## ***KODAK* MULTILOADER 300**

Service Code 3058

### **Modification No. 38**

To ensure that the bottom FILM CHUTE SENSOR B35 detects all type of films.

figure 1

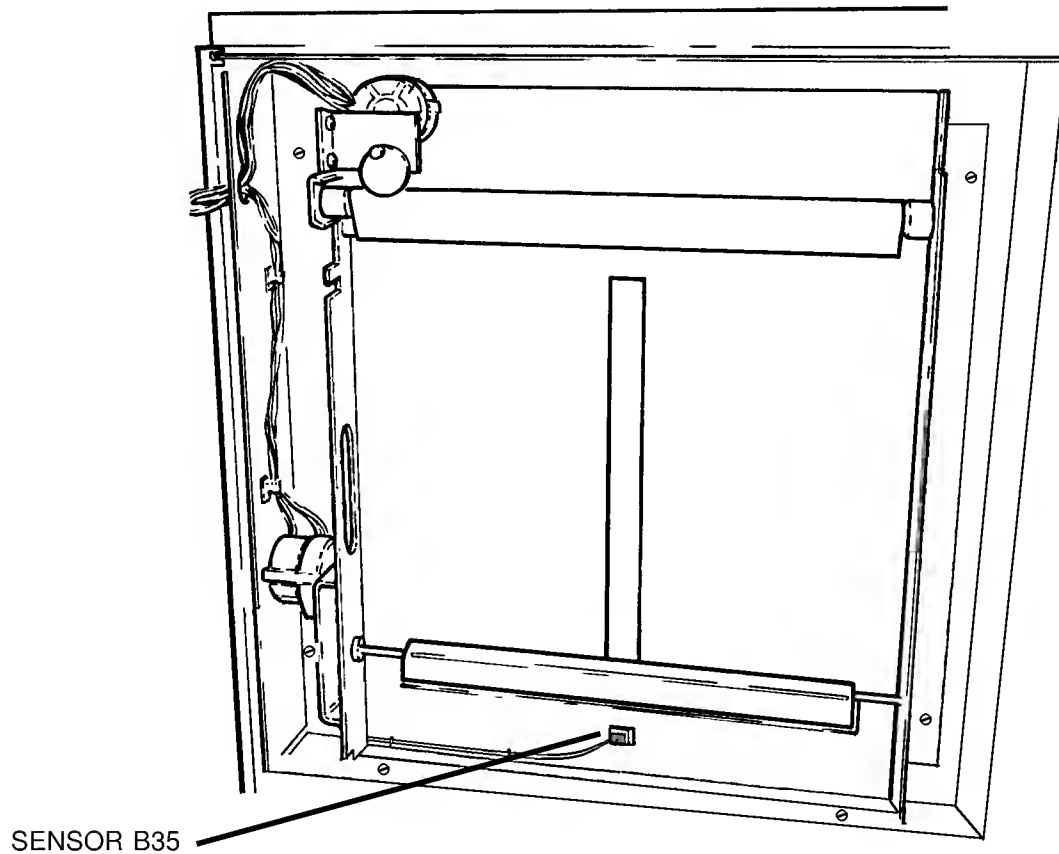
1. Switch off the ML300 .
2. Take off the PANELS.
3. Take off and discard the existing MOUNTING BRACKET of SENSOR B35.

figure 2

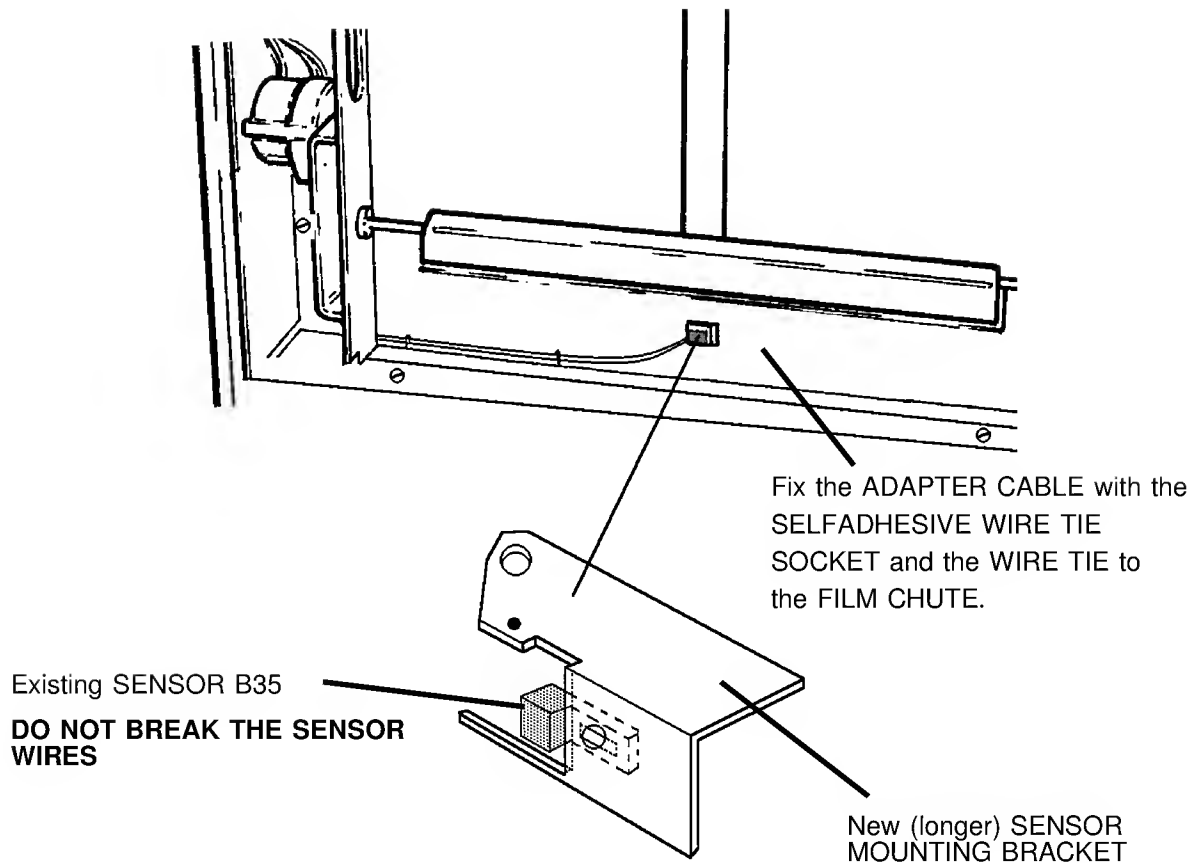
4. Mount SENSOR B35 onto the new (longer MOUNTING BRACKET. See the drawing on the next page.

5. Connect the new ADAPTER CABLE in between the SENSOR B35 and the existing CABLE. See the figure on the next page.
6. Fix the ADAPTER CABLE with the SELFADHESIVE WIRE TIE SOCKET and WIRE TIE to the FILM CHUTE.

figure 4

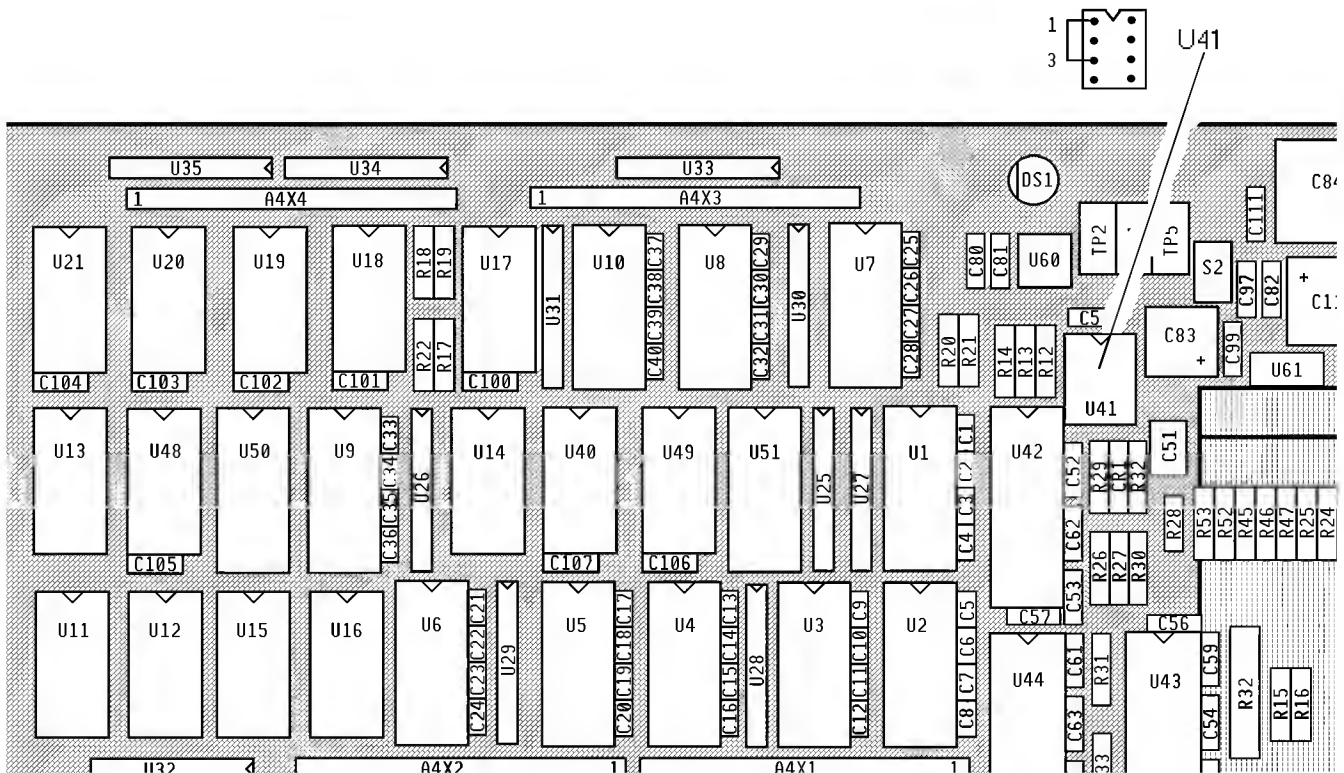
1. Ensure that the XML300 is switched off.
2. Pull out U41 off PCB A4.
3. Connect PIN 1 to PIN 3 at the SOCKET of U41.

4. Connect the DVM to TP12 of PCB A4 and to TP11(GND PE) of PCB A4 (for the location of the TEST PINS see figure 5 for the wiring diagram see figure 3 ).
